**RE: Main Street Living, LLC
Proposed Mixed-Use Development
and Townhouse Development
Block 1, Lots 31, 33.01, & 34-36
7-9 Main Street &
11-13 Railroad Avenue
Township of Robbinsville
Mercer County, NJ
DEC # 5214-24-00441
Application #R25-03-01**

This letter shall serve as the formal response to the following Township of Robbinsville professional review letters and memorandums:

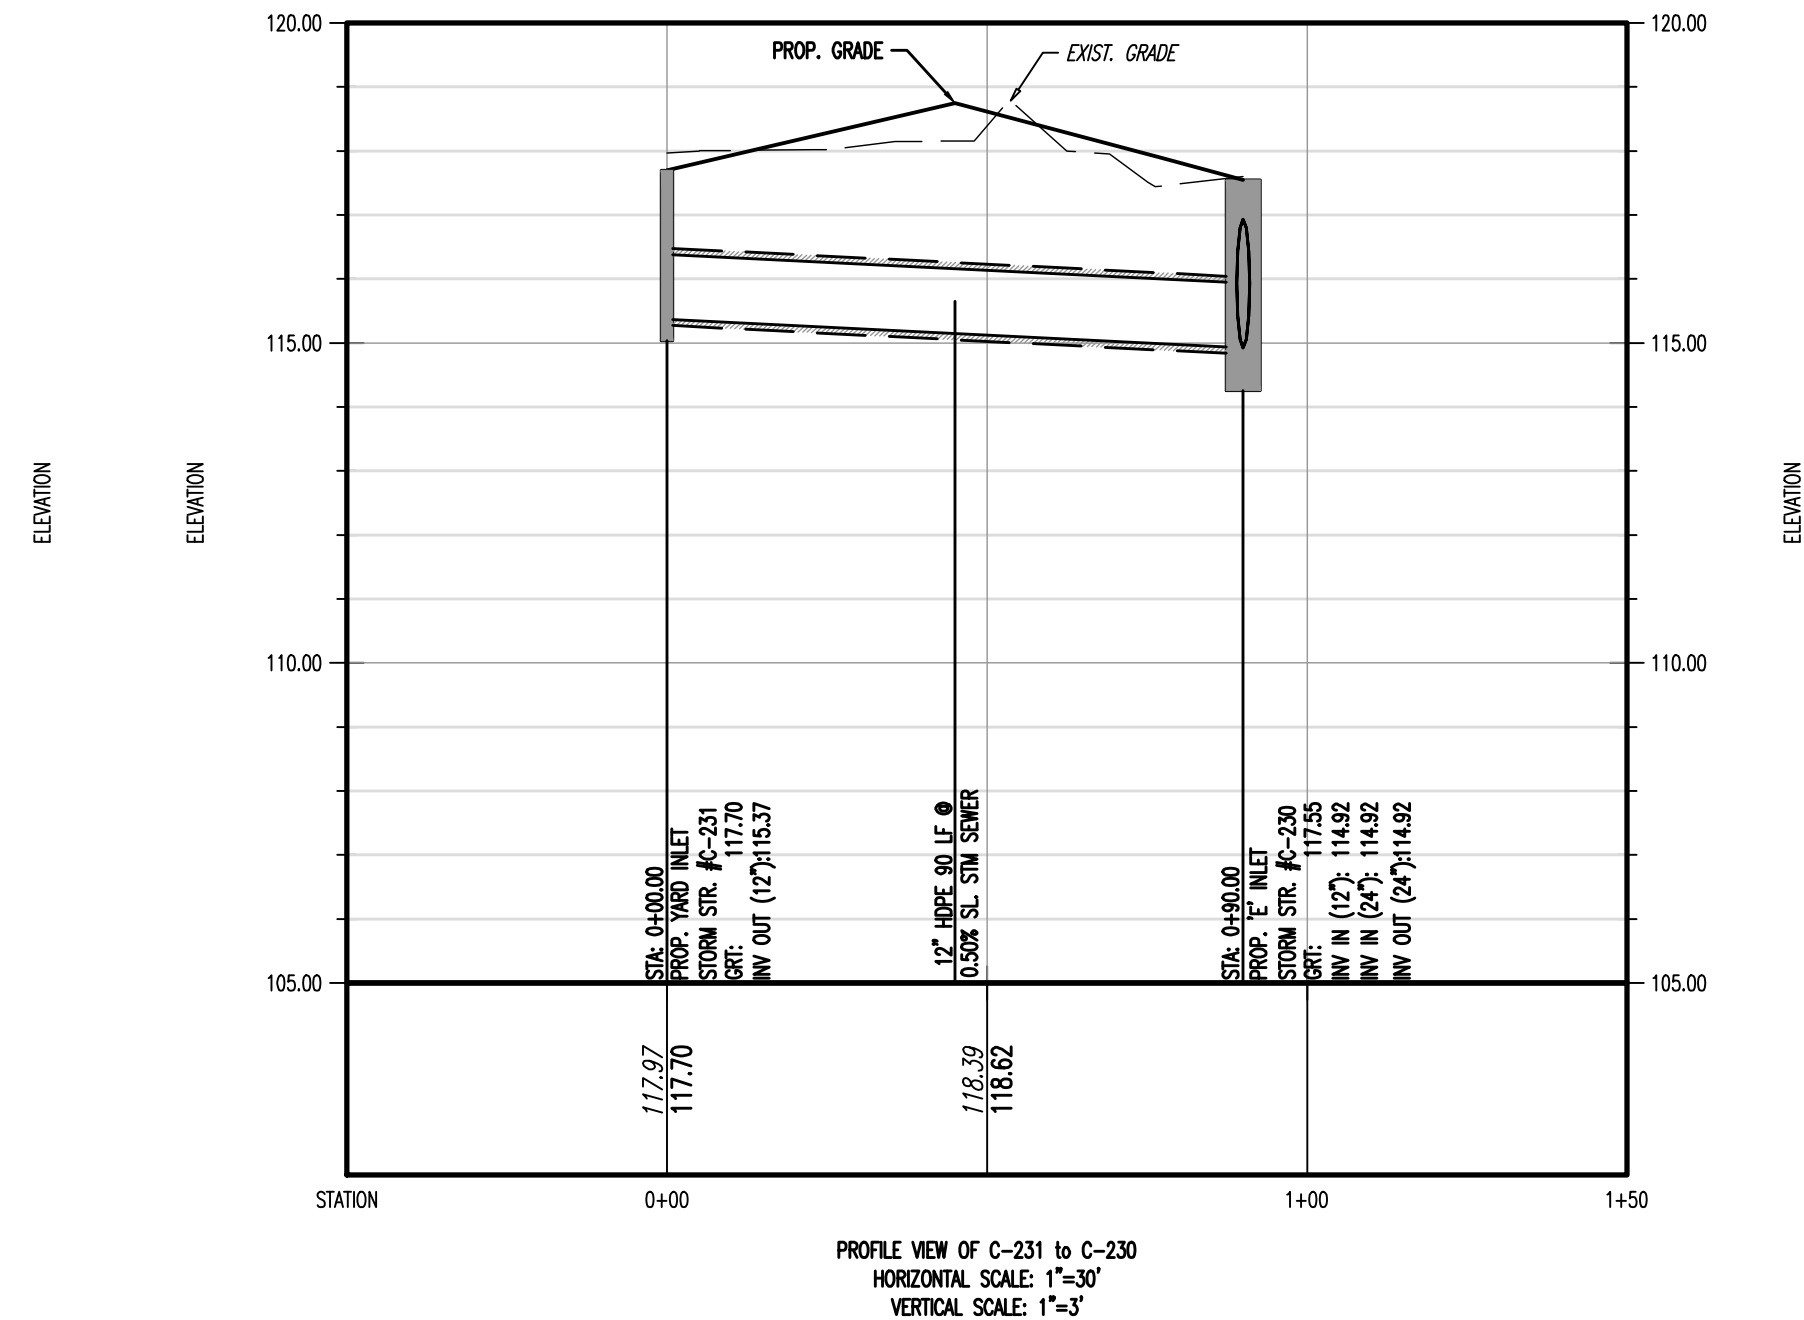
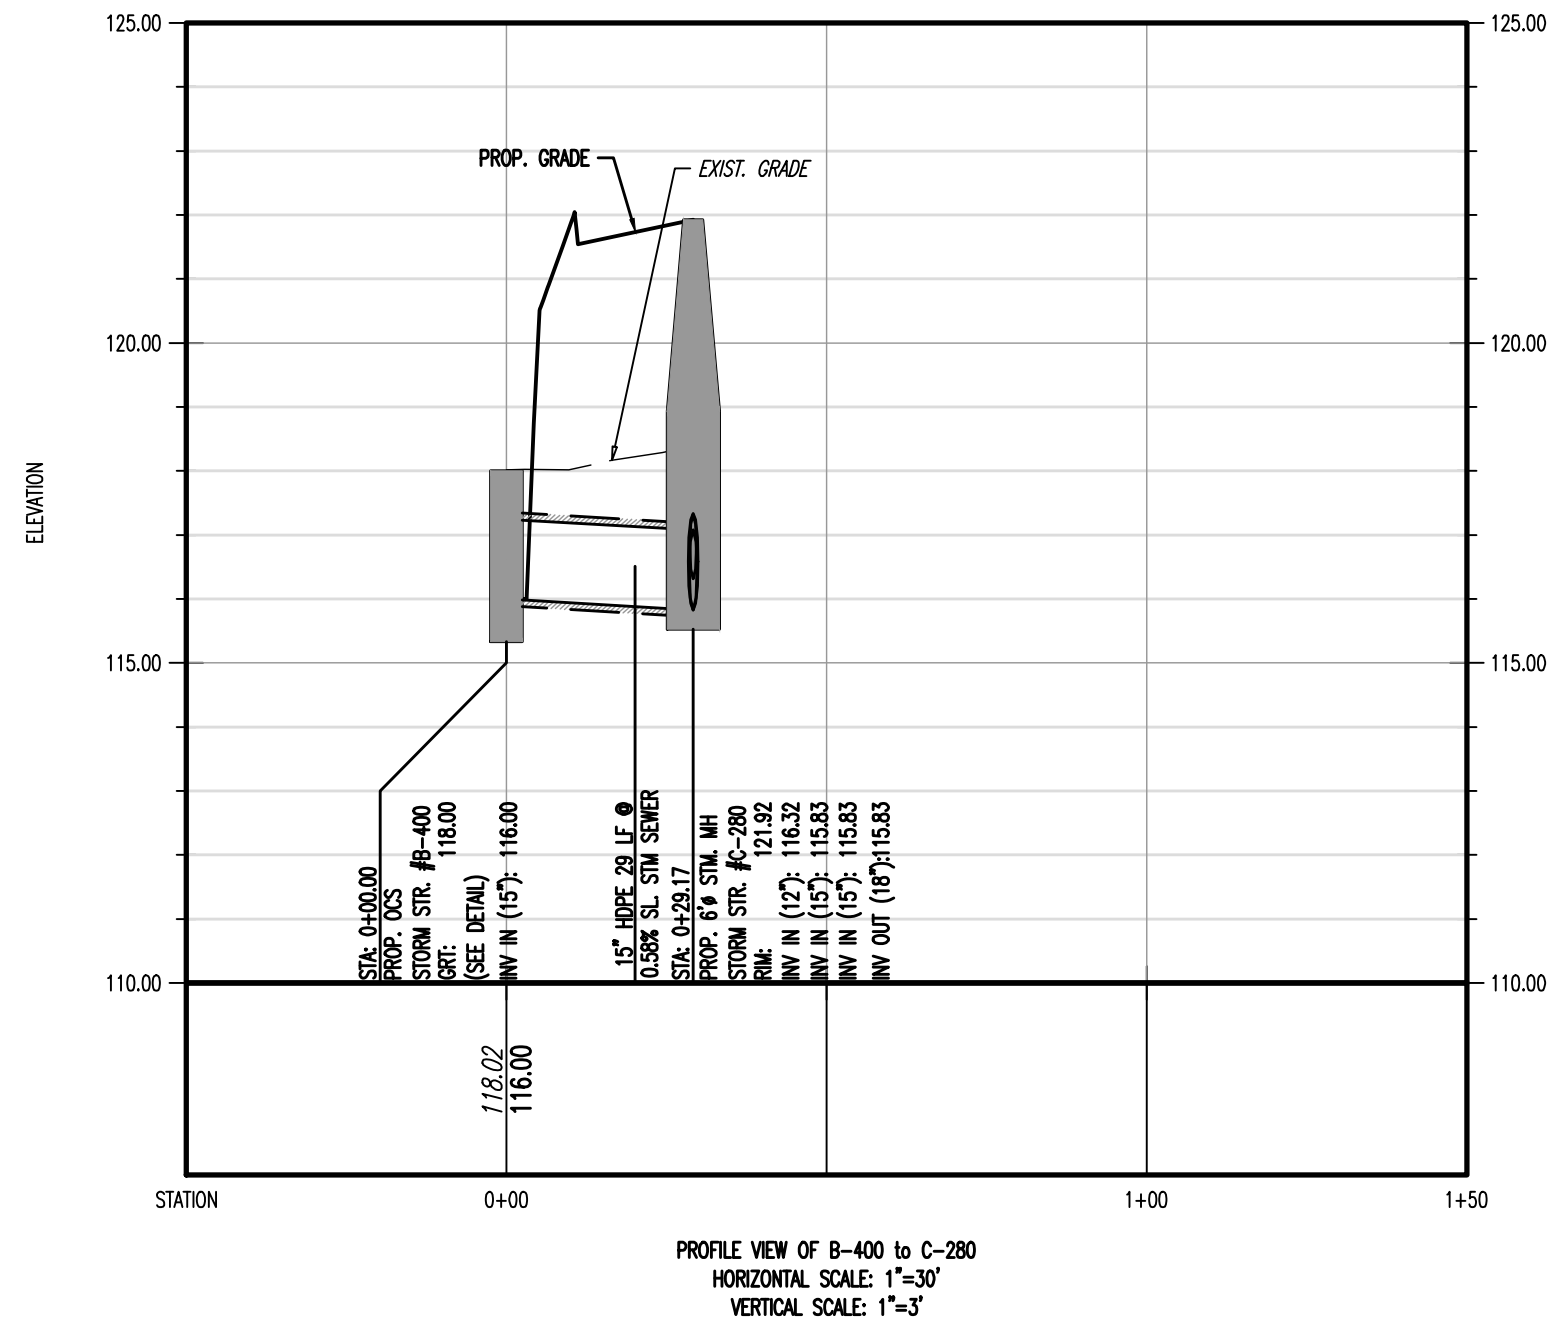
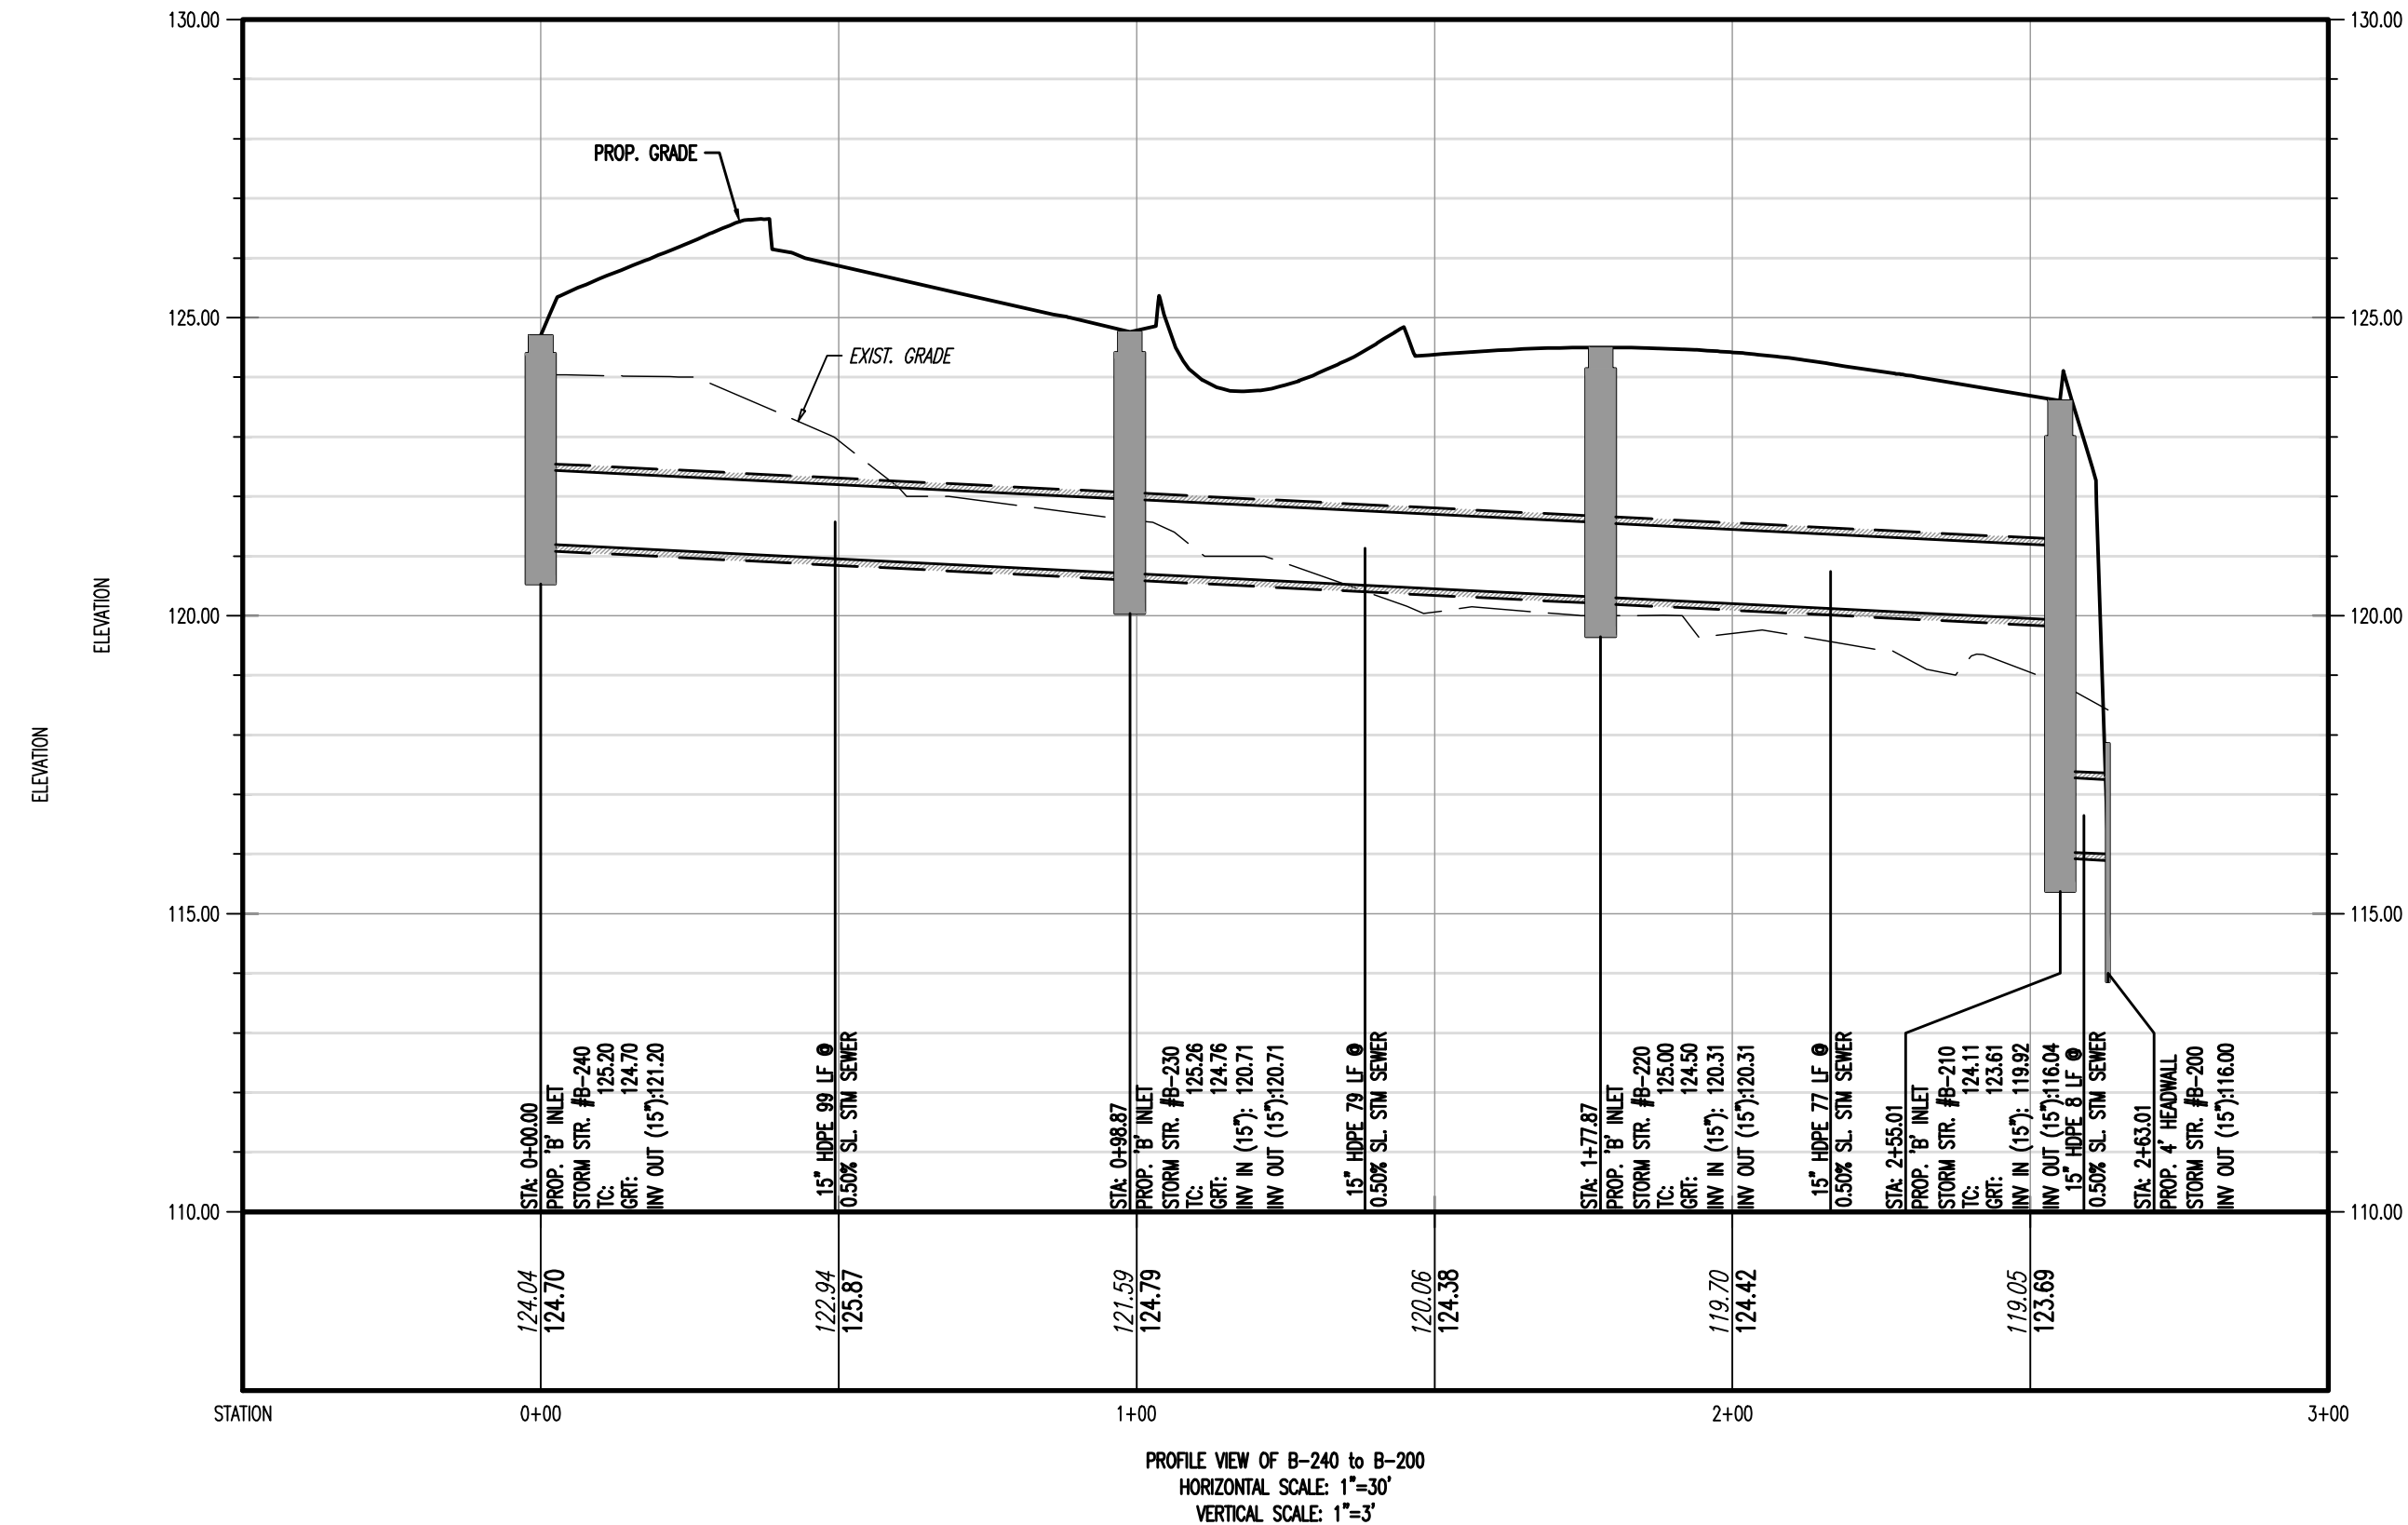
18. *Clarify the pipe crossings in the drainage profiles as it appears pipes are in direct conflict with each other. Revise text overlaps within the drainage profiles.*

The Drainage Profiles (Sheets 29-31 of 31) will be revised to remove text overlaps and pipe conflicts as a condition of approval.
